### Development Review Committee (DRC) Meeting

Tuesday, September 5<sup>th</sup>, 2023 – 9:30 AM

**Subject Case # 23-01-FSP-Safety Town**

**Applicant: Florida Public Utilities Co.**

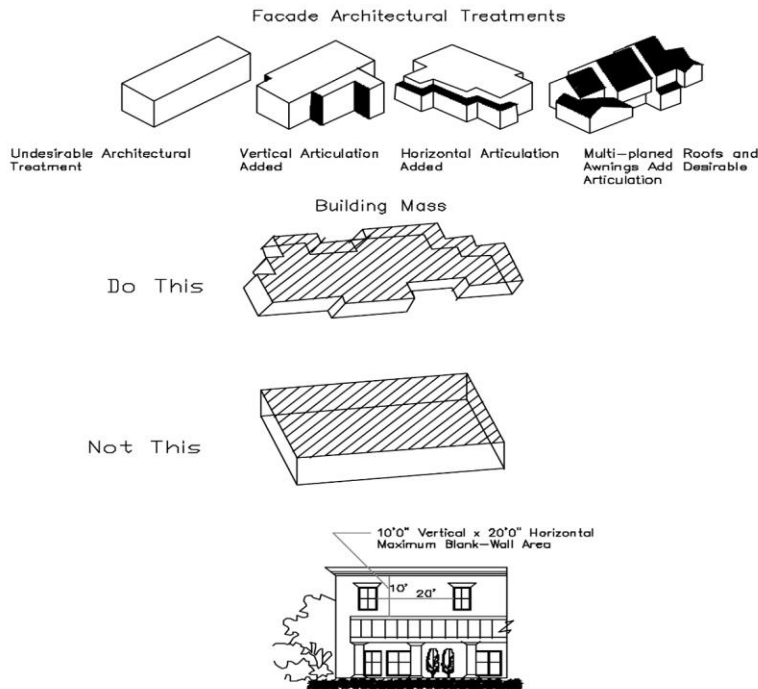
Section 5-123(a) states the architectural standards for the Gateway Corridors apply to all new development except for single-family dwellings, two-family dwellings, and alterations of certain structures. Therefore, this project is subject to this Section. **Please provide detailed architectural renderings and elevations of the simulation houses so that staff may determine compliance with Section 5-123(b).**

Section 5-123(b)(2)b states structures less than 5,000 square feet shall have no building façade with an uninterrupted horizontal length exceeding 35 linear feet. **The sides of the storage building have 40 linear feet of uninterrupted façade. Please see the below image for more information:**

SHEET TITLE: LANDSCAPE PLAN

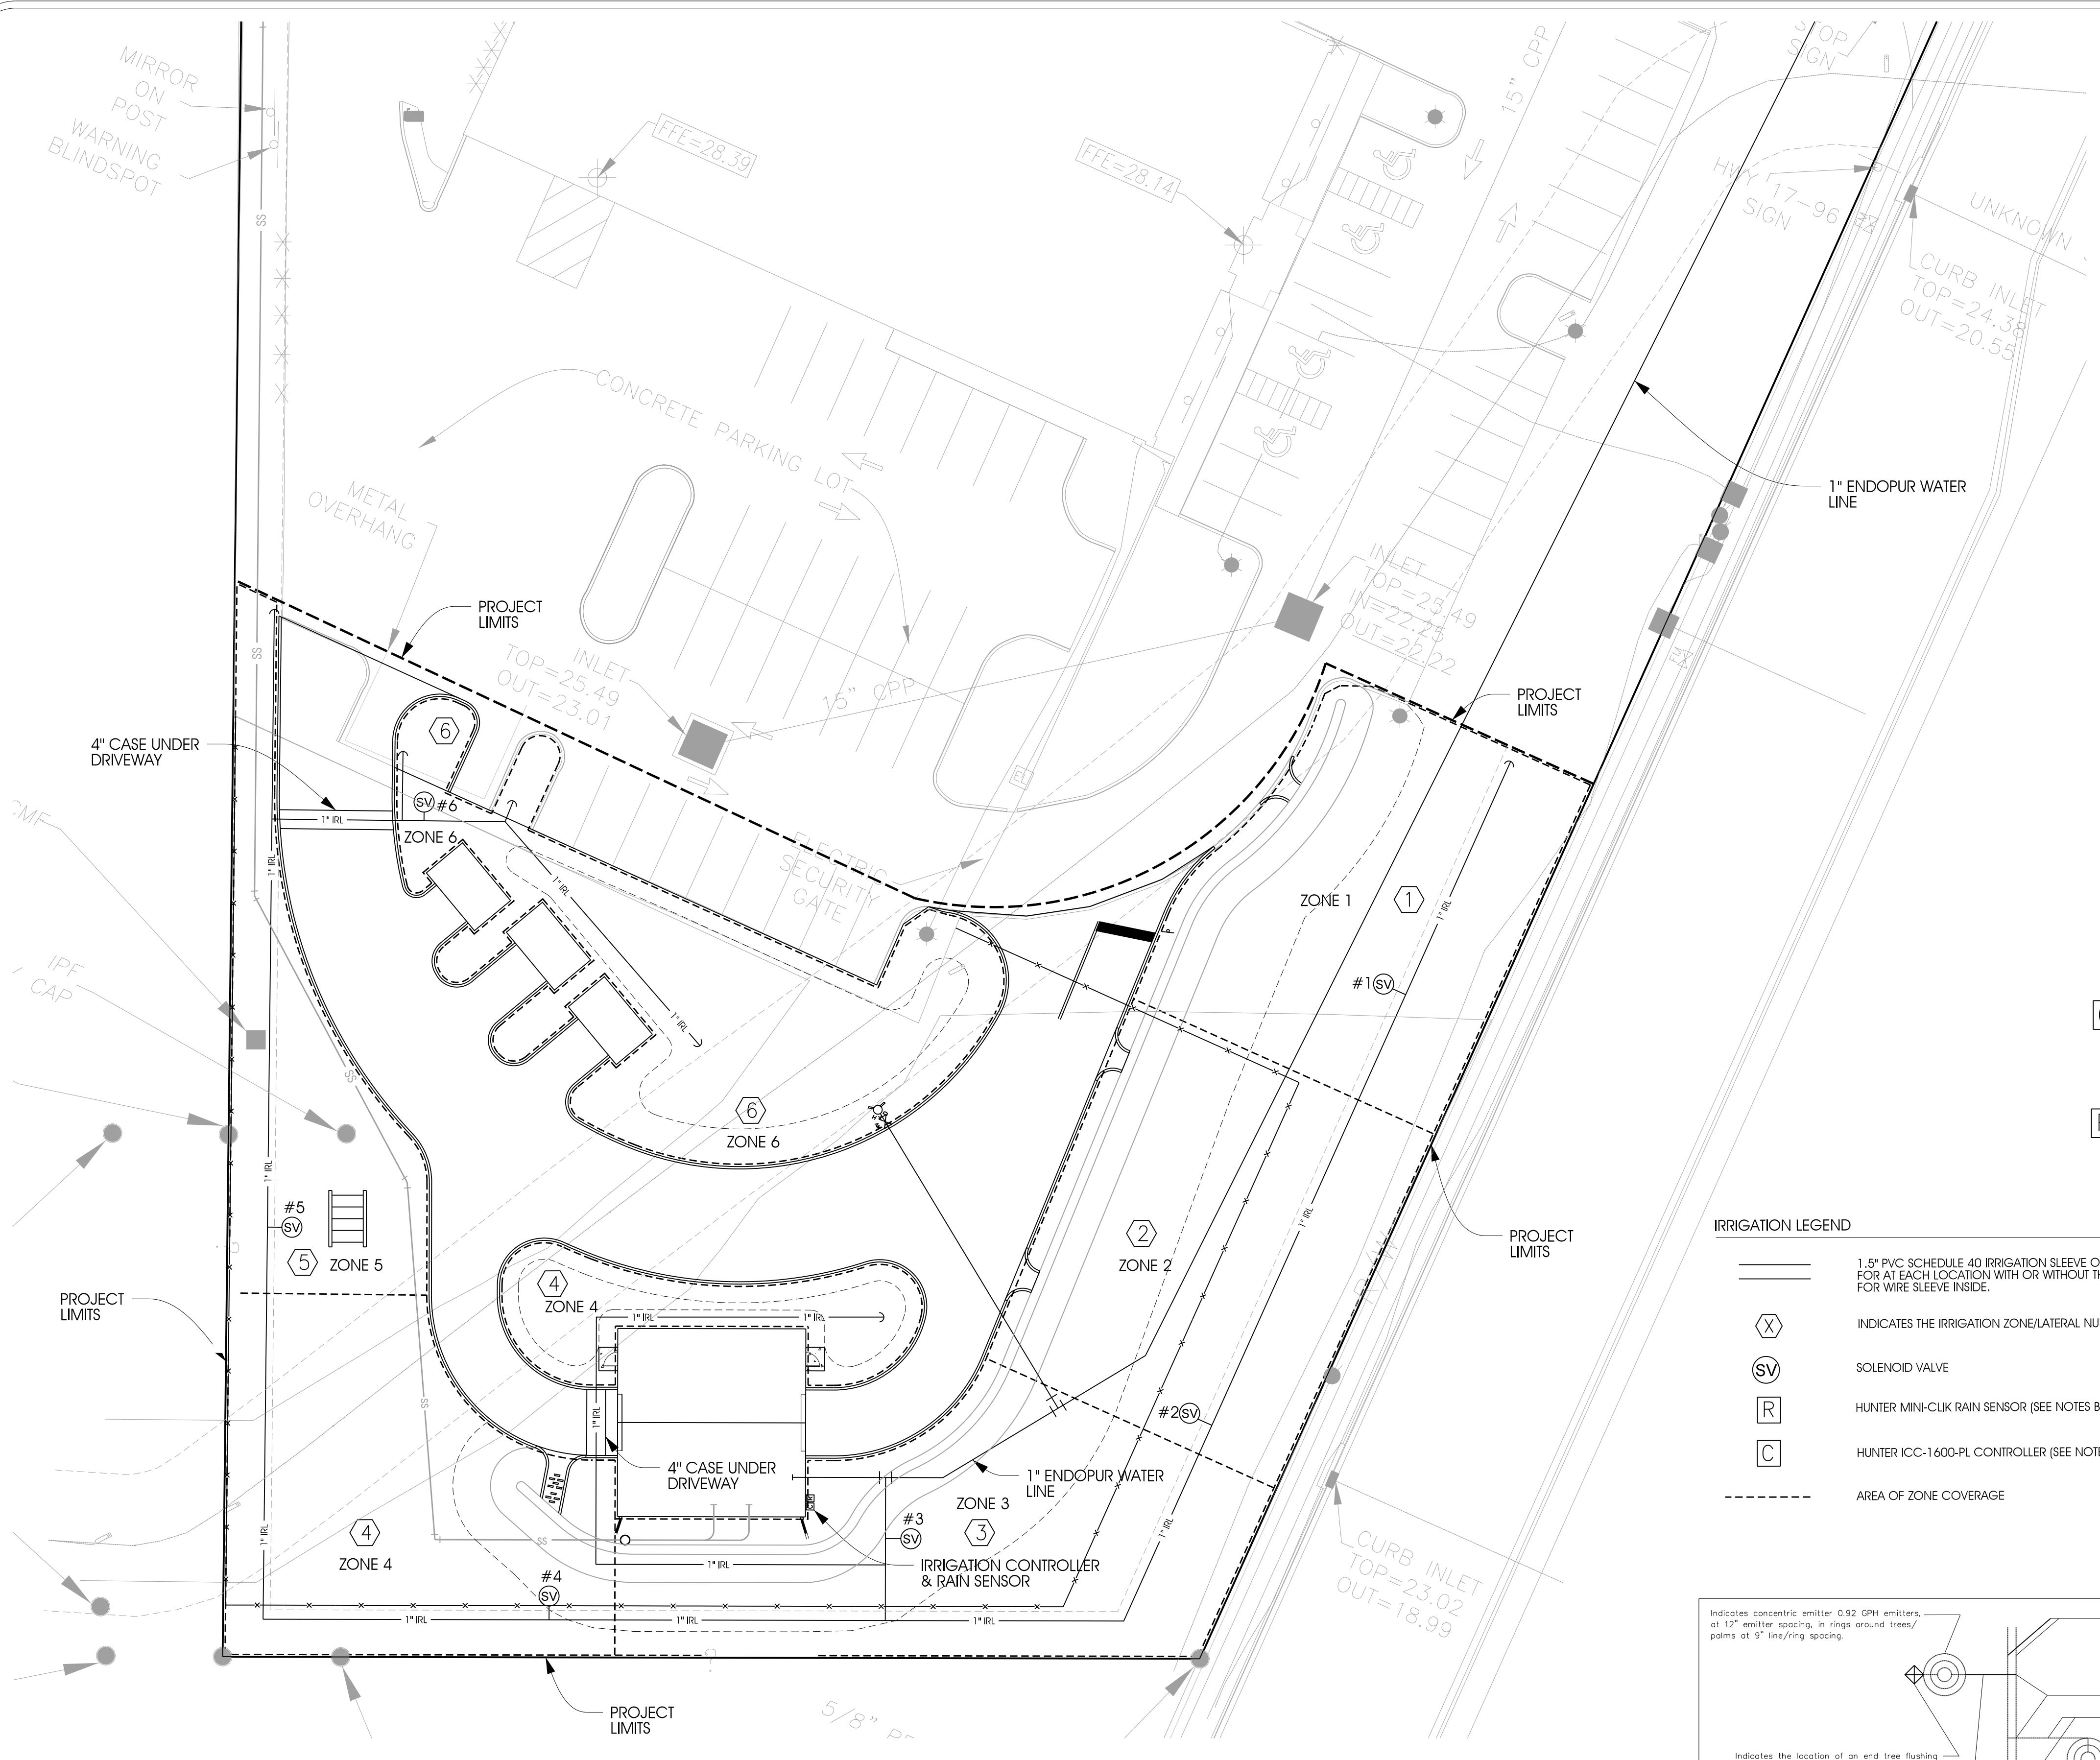
Section 5-7(a) requires landscape areas to be located adjacent to all building perimeters. The minimum depth shall be 5 feet. **The depth on the proposed plan appears to be 3 feet. Please increase to 5 feet.**

Please note the end of planters next to parking stalls shall be set back 2 feet from the driving aisles, as per Section 5-8(d). Please verify.

Section 5-8(e) requires interior planters in vehicular use areas to be at approximately the same elevation (adjusted for curbing) as the adjacent vehicular use area, except as necessary to save existing trees. **Please add note stating so.**

Section 5-10(c) provides for planting design and distribution. **The landscape area depth of the front yard is over 50', thus requiring 4 small trees per 80 lineal feet. The number of lineal feet of landscaping area is 224 feet. This will require a total of 11 small trees. Only 7 have been provided in the front yard. Please provide an additional 4.**

Section 5-10(e) requires a certain number of species based on the number of trees required. The required number of trees exceeds 40, thus requiring 5 species. **What are the species of the existing trees?**

Section 5-10(h) requires at least 25% of the site's total required landscape area to be covered by shrubs, ground covers, or vines. **Please provide this data.**

Section 5-10(h) requires the cross slope of mulched plantings beds to not exceed 1-foot vertical to 6 feet horizontal. **Please verify and provide note stating such.**

Section 5-10(i) requires all landscape areas to be designed with plant spacing to achieve coverage of 80 percent of the landscape areas with living organic plant materials within two years. **Please add note stating such.**

Section 5-10(k) requires slopes for lawn grasses to not exceed 1-foot vertical to 3 feet horizontal. **Please verify and provide note stating such.**

Section 5-11(d) states where overhead utility lines are within 25 feet of required shade tree trunks, small ornamental trees shall be substituted at a rate of 1.5 small trees for each required shade tree. **Just outside of the eastern boundary of the property, there are overhead utility lines. Please verify if these are within 25 feet of the trunks of the shade trees**
